Draft corrigendum to ECE/TRANS/WP.29/GRSP/2010/36

(REGURATION No.80 (Strength of seats and anchorages in buses))

Figure 1: Positioning requirements for side-facing seats

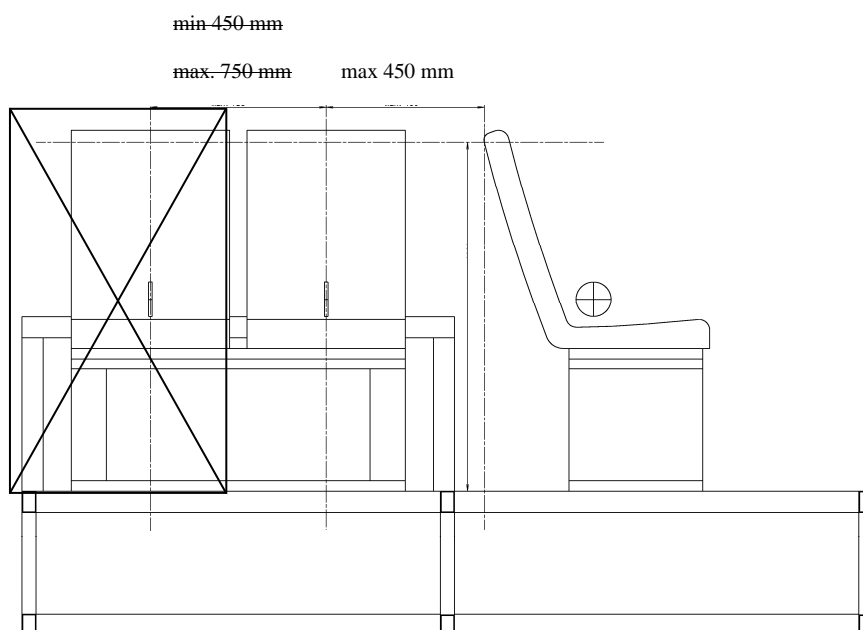
Appendix 7, Figure 1., amend to read

During the test for the safeguarding of passengers in side-facing seats (Appendix 7), it is not necessary to describe two seats on Figure 1 in Appendix 7, as the dummy is only positioned on the side-facing-seat behind the front-seat (test seat).
